Besta Apparels (New)

666/1, Gasa, Boad Bazar, Ward#36, National University-1704, Gazipur
(23.941965N, 90.369348E)
06th June 2018

Discrepancy observed between As built drawing and on site condition

Provided Beam Layout

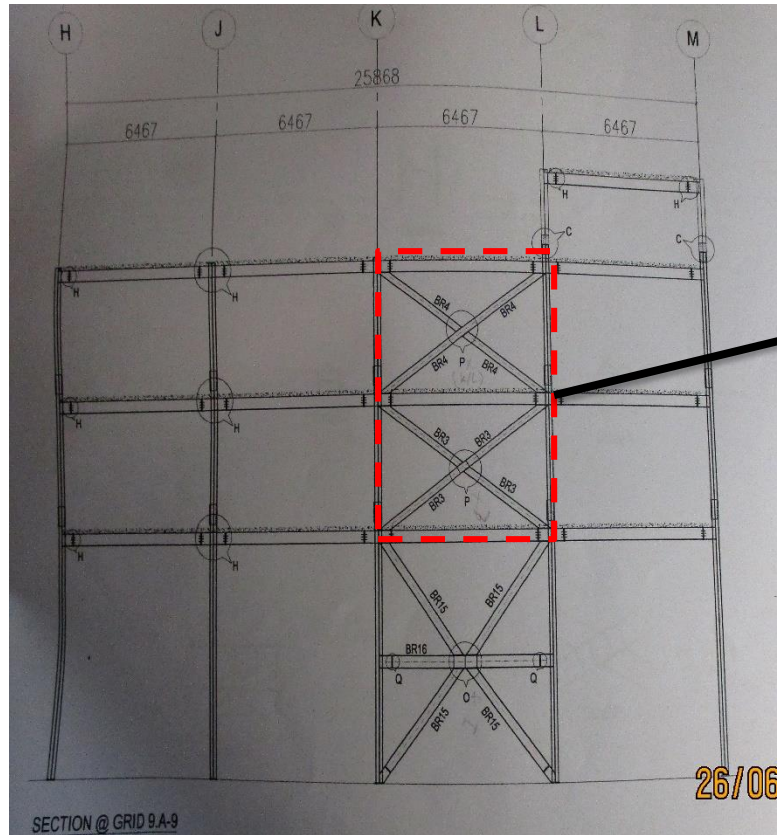
Beam layout provided in as-built structural drawing does not match with on site placement of beam on stair case. Three beams were found on site between grid shown on the provided beam layout which were not in drawing.

Three beams found on site

Provided Bracing Layout at grid 9A-9

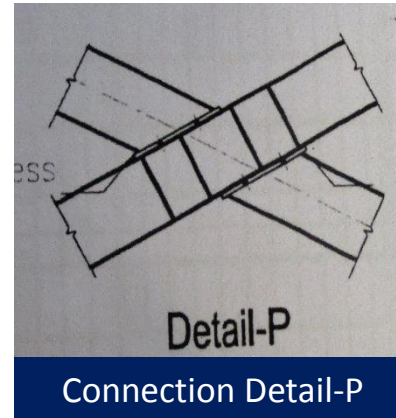
As per provided as-built drawings connection of bracing between grid K&L on 1st & 2nd floors was supposed to be represented by detail "P". But on site the connection found represents detail "K".

Connection found on 1st & 2nd floor

Provided Bracing Layout at grid 9A-9

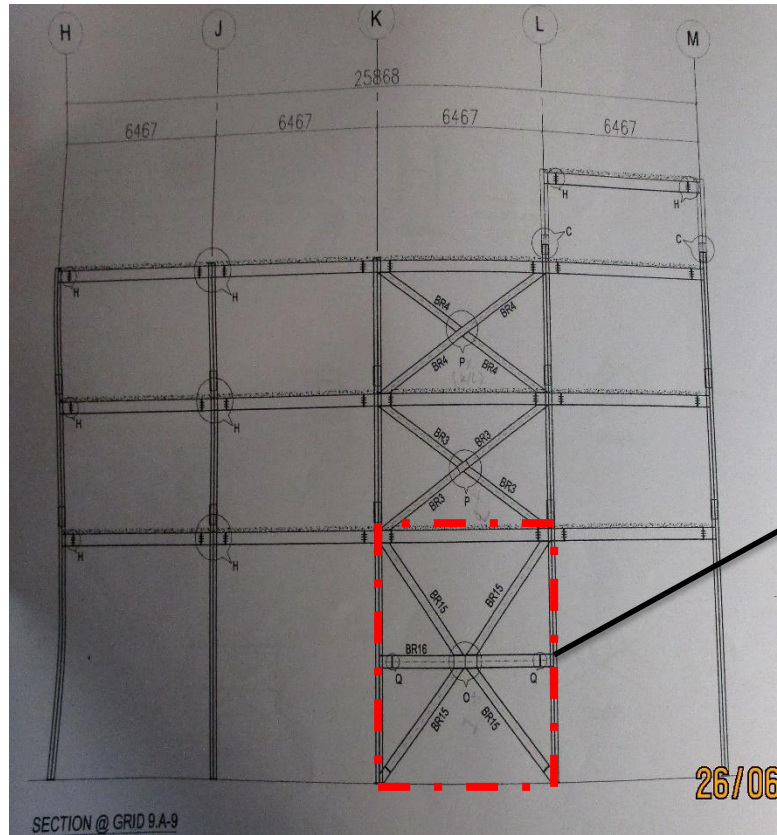
As per provided as-built drawings connection of bracing between grid K&L on ground floor was supposed to be represented by detail "O". But on site the connection found represents detail "I".

Corrosion observed at steel sections

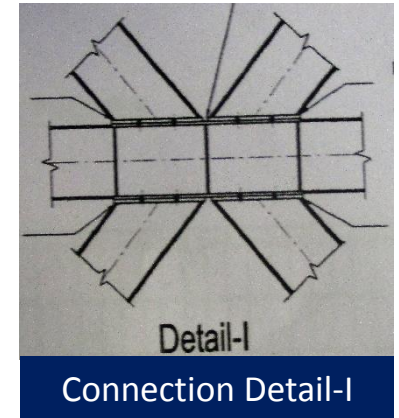
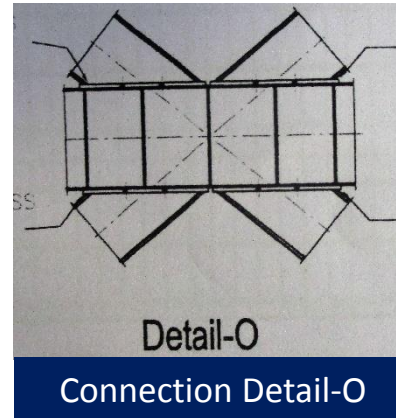
Corrosion observed at the joint of column and bracing.

Corrosion was observed on steel column at roof top.

Corrosion was observed on steel columns on roof top and at the joint of column and bracing. Factory is required to identify the corroded locations and take proper remedial measures.
